The amendment revises Section 6.0 Administrative Controls of Appendix A and organization figures of Appendix B to reflect recent organization and management title changes.

JAMES A. FITZPATRICK NUCLEAR POWER PLANT

AMENDMENT TO FACILITY OPERATING LICENSE

Amendment No. 60
License No. DPR-59

FIGURE 6.1-1

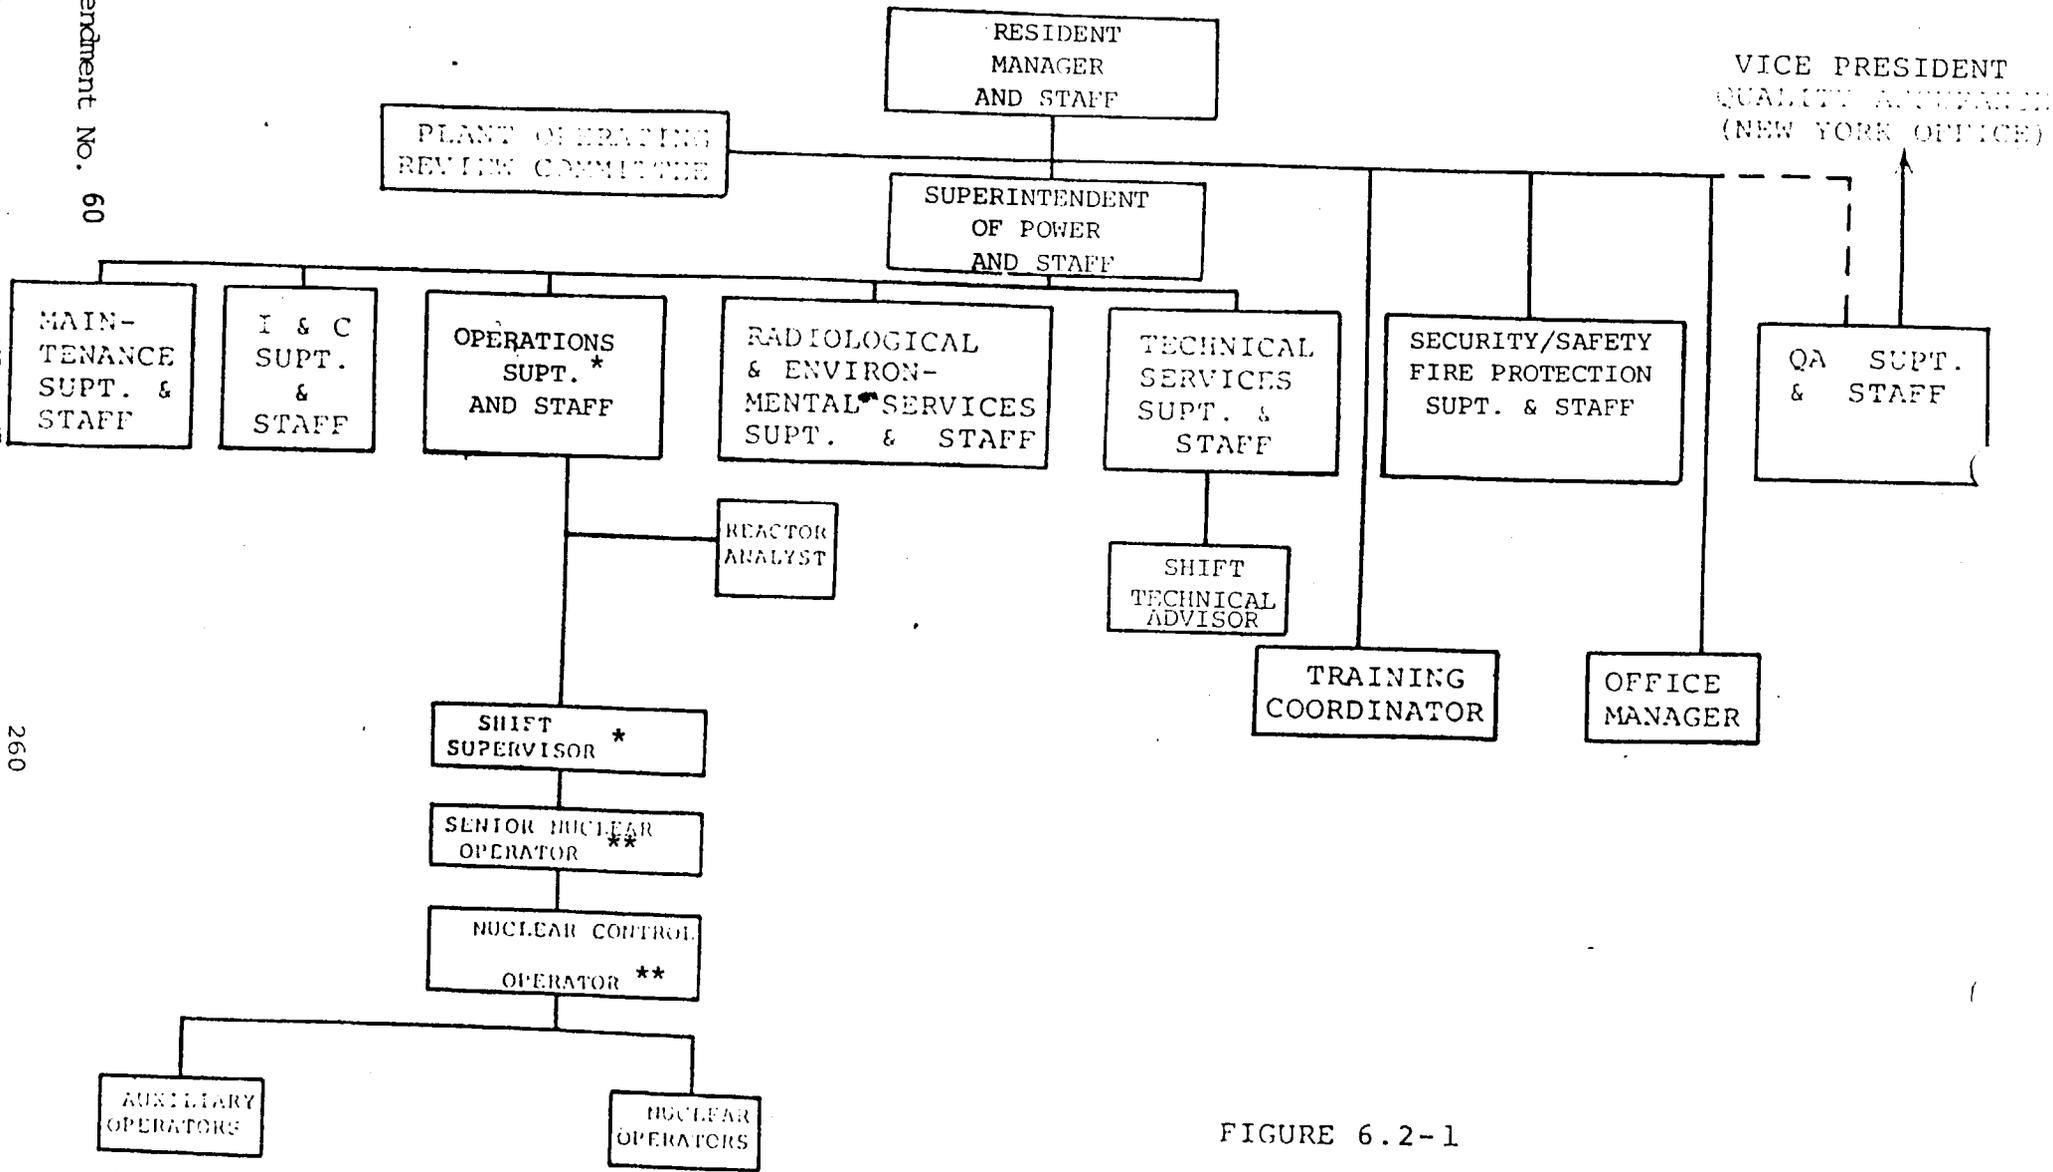
The Resident Manager is responsible for safe operation of the plant. During periods when the Resident Manager is unavailable, the Superintendent of Power will assume his responsibilities. In the event both are unavailable, the Resident Manager may delegate this responsibility to other qualified supervisory personnel. The Resident Manager reports directly to the Sr. Vice President-Nuclear Generation, as shown in Fig. 6.1-1.

FIGURE 5.2-1
POWER AUTHORITY OF THE STATE OF NEW YORK
JAMES A. FITZPATRICK NUCLEAR POWER PLANT
PLANT ORGANIZATION - RADIOLOGICAL ENVIRONMENTAL

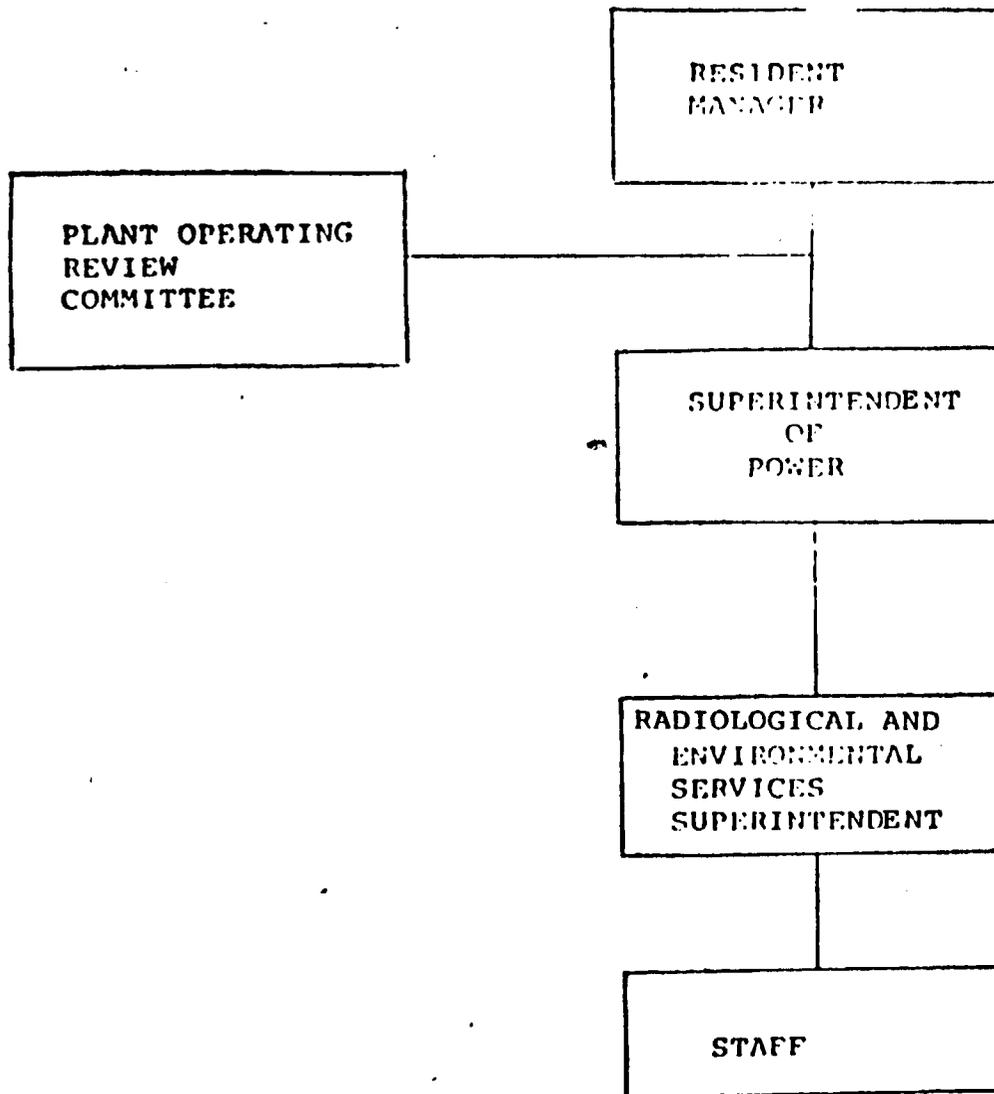
The amendment revises Section 6.0 Administrative Controls of Appendix A and organization figures of Appendix B to reflect recent organization and management title changes.
